40cc Gas Chain Saw

P350S

SERVICE SPARE PARTS LIST

Illustrated Parts List - IPL Update

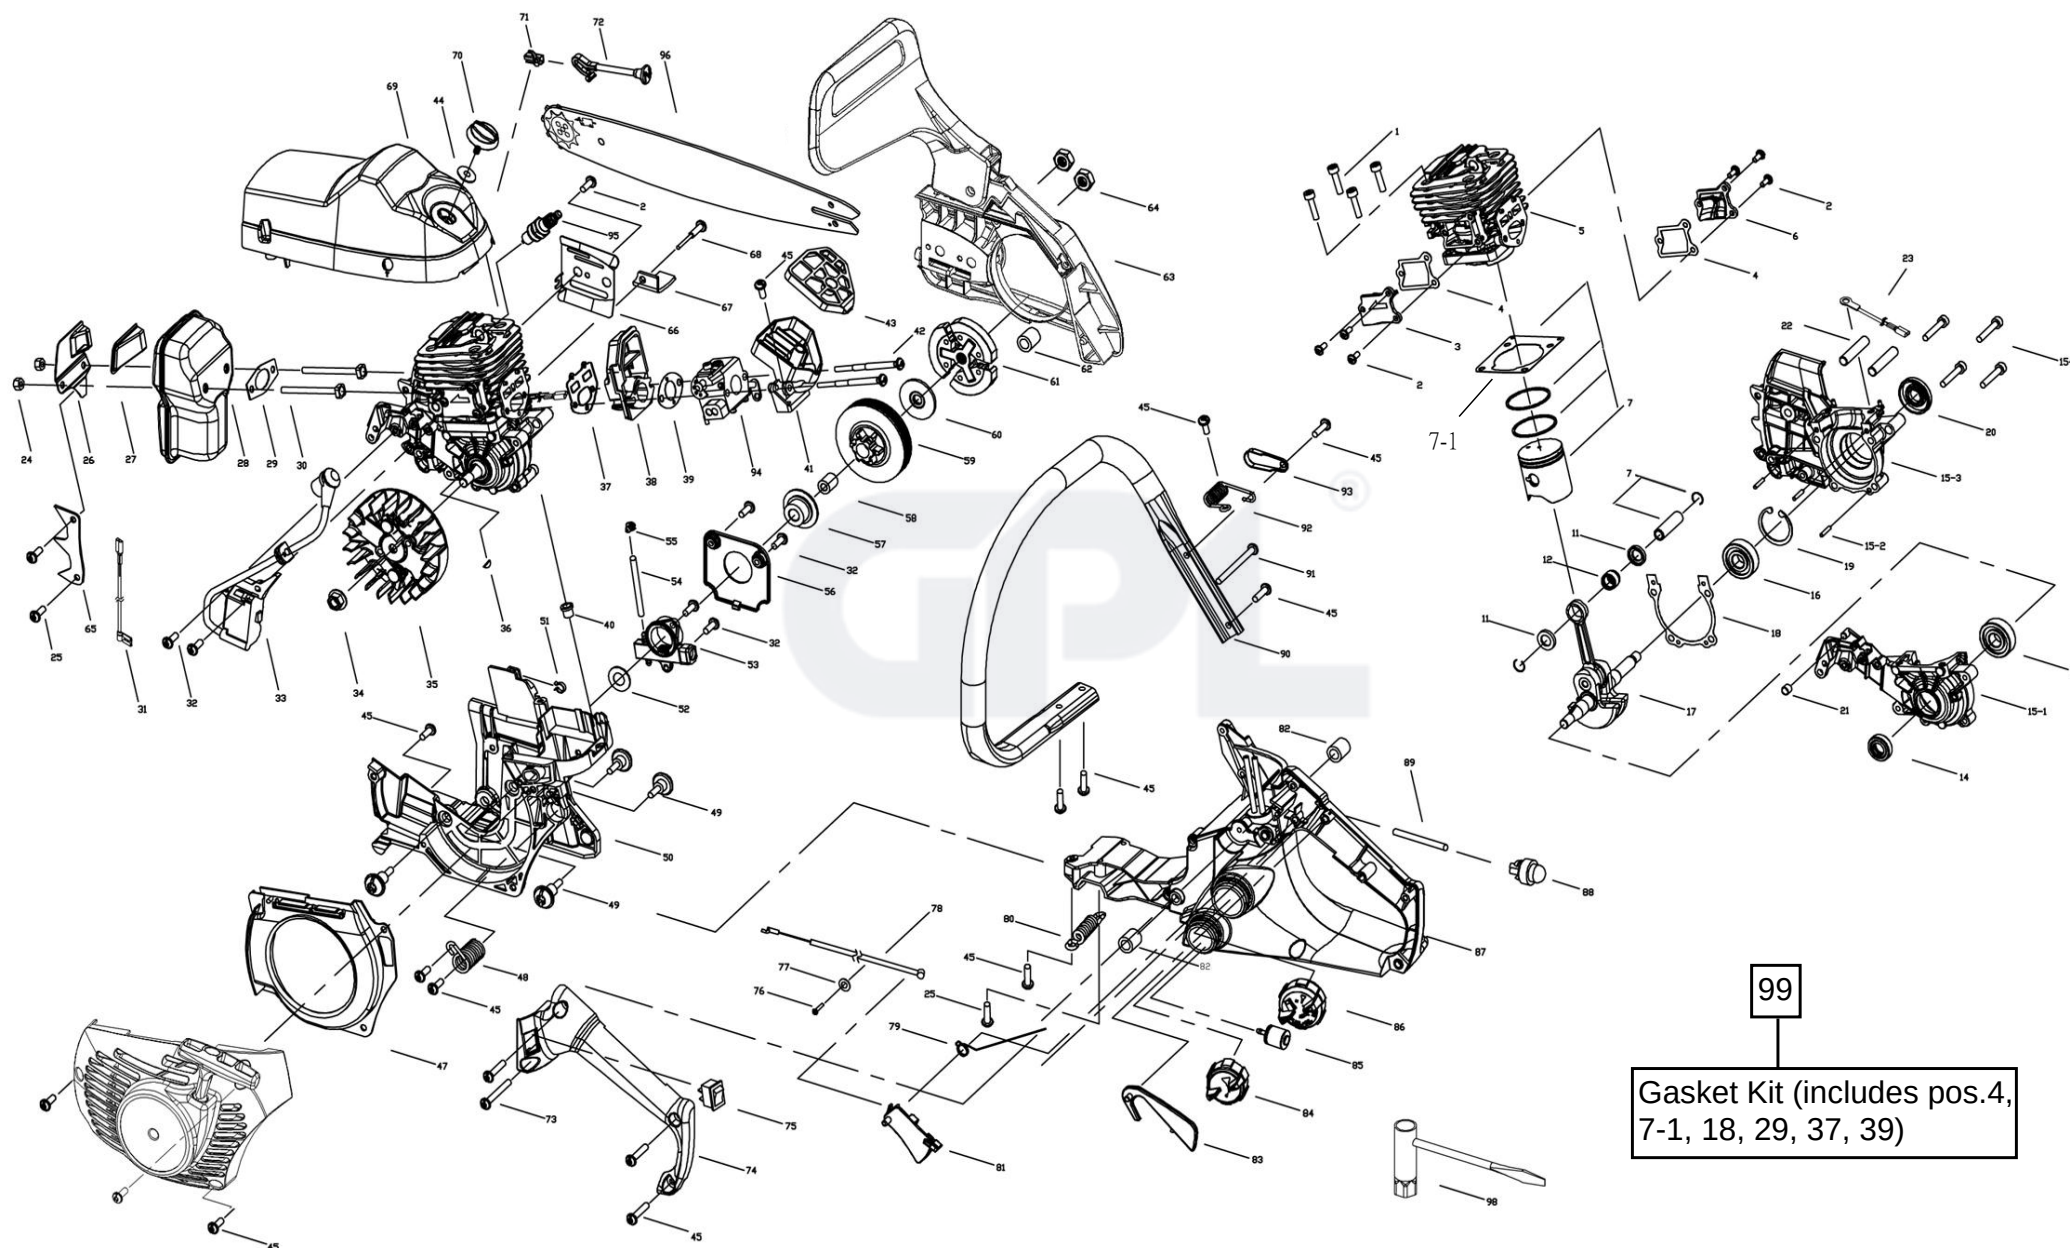
- 1. Screw: Cylinder screw change to Dri-Loc screw instead of add glue**
- 2. Muffler: Remove catalyst for Russia models**
- 3. Starter Housing Assy: Changed to improved soft starter system**
- 4. Oil Pump: Design changed to improve the quality**
- 5. Oil Tank Cap: Color changed to Husqvarna light grey**
- 6. Carburetor: Ruixing carb instead of Walbro**

Page Title	Ref. no	New Part no	Name	Remark
page 2	1	584955901	Screw	Dri-Loc
	28	583836901	Muffler Assy	EU model
		583836902	Muffler Assy	Russia model
	46	585846001	Starter Housing Assy	Soft starter
	53	581339101	Oil Pump Assy	
	84	585845901	Oil Cap Assy	Grey color
	94	581302401	Carburetor H182A	40cc
